<b>Consultee Response</b>	Built Historic Environment
<b>Consultee</b>	Jane Corfield
<b>Response Date</b>	28.05.2026
<b>Reference Number</b>	25/LBC/00515
<b>Location</b>	Former Tunstall Library and Baths, Drill Hall and 17-19 Greengates Street, Tunstall, Stoke-on-Trent
<b>Description</b>	Proposed selective demolition, extensions, elevational alterations, external stores and sub-station enclosures, and associated internal interventions (Listed Building Consent)
<b>Case Officer</b>	David Clarke

LD101 looks like this in the heritage statement:

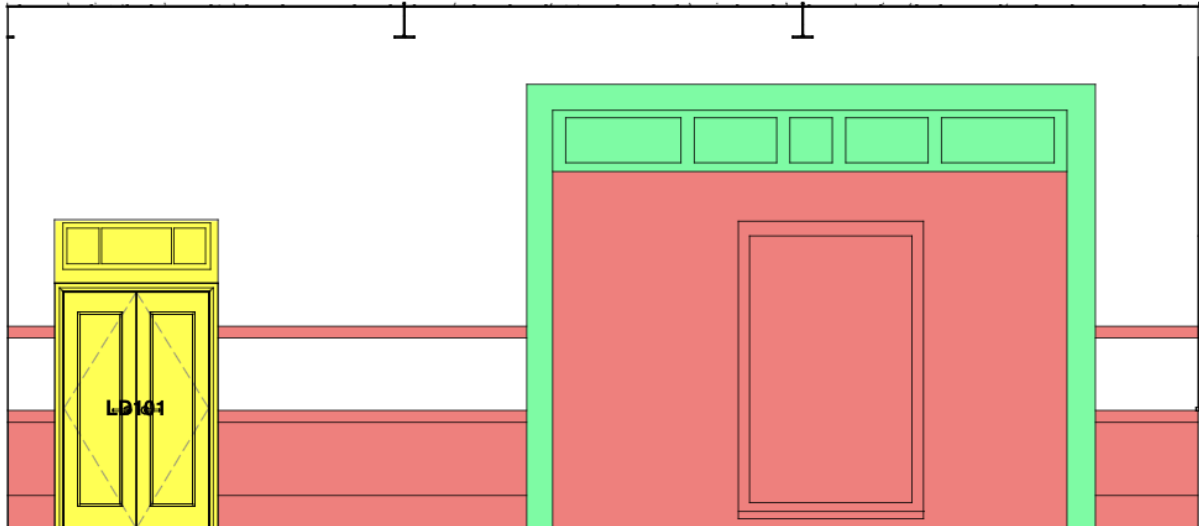
A pair of double doors with raised and fielded panels below glazing, itself probably replaced with a board based on the fact that the statement goes on to say that these doors match those to FO14 which are glazed.

This door is shown incorrectly as fully glazed or panelled, not as photographed.

LD101 door and frame removed and reused in LS007 (as LD264). Wall panelling dado rail, pipework and conduits all removed. Roller shutter and chalk board removed with frame around shutter retained

LD008 is shown as

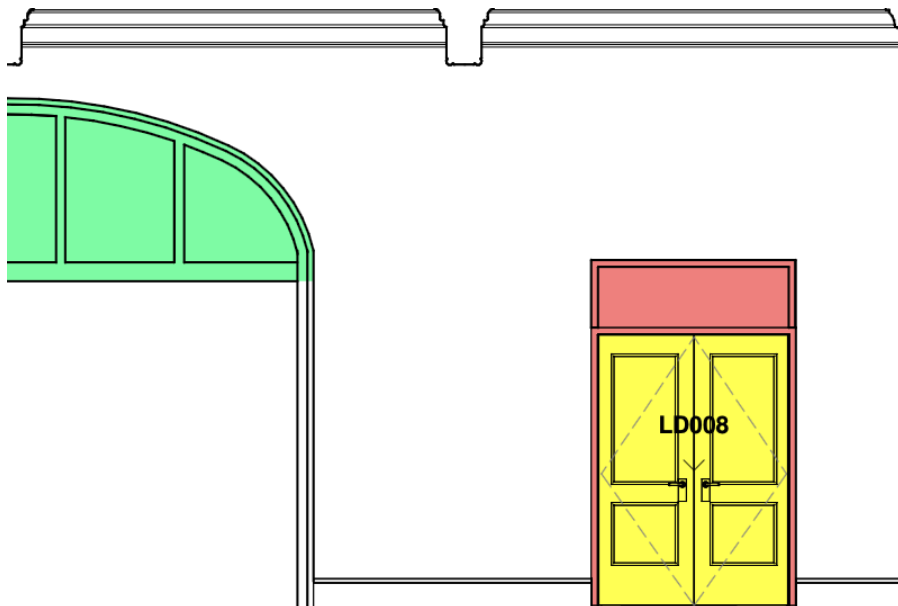
A photograph of this door shows it to be modern and not matching LD101. Why has it been saved? Why has it been placed opposite a door of differing design? These doors will look mismatched and, given there is no clear reason for retention of the modern door or strategic approach, they will not conserve the significance of the building.

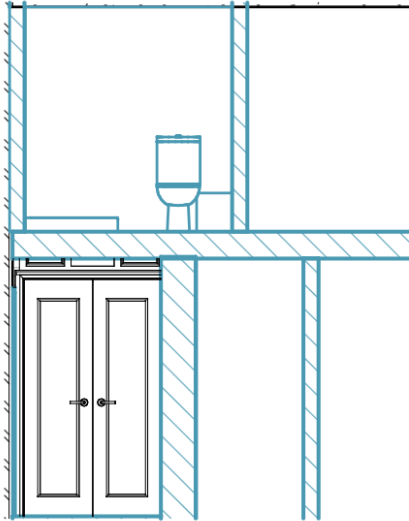
According to the heritage statement, the door to FO14 which does match LD101 is now called LD100 and is to be moved to S007 a corridor on the second floor. However, the door schedule indicates

that the door is not reused. This is then contradicted by the room detail sheet that shows it retained, but fixed open and a new mezzanine built across the fanlight. The Room-by-Room Assessment of Impact fails to mention the fact that the floor goes across the fanlight meaning that it won't be seen as the two elements collide.

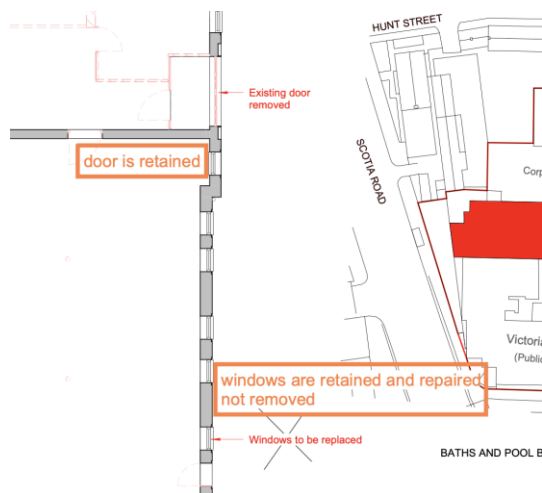
The photographs on proposed plans **2620 - L-3-03 D** are also misleading, showing floor cut-aways next to windows.
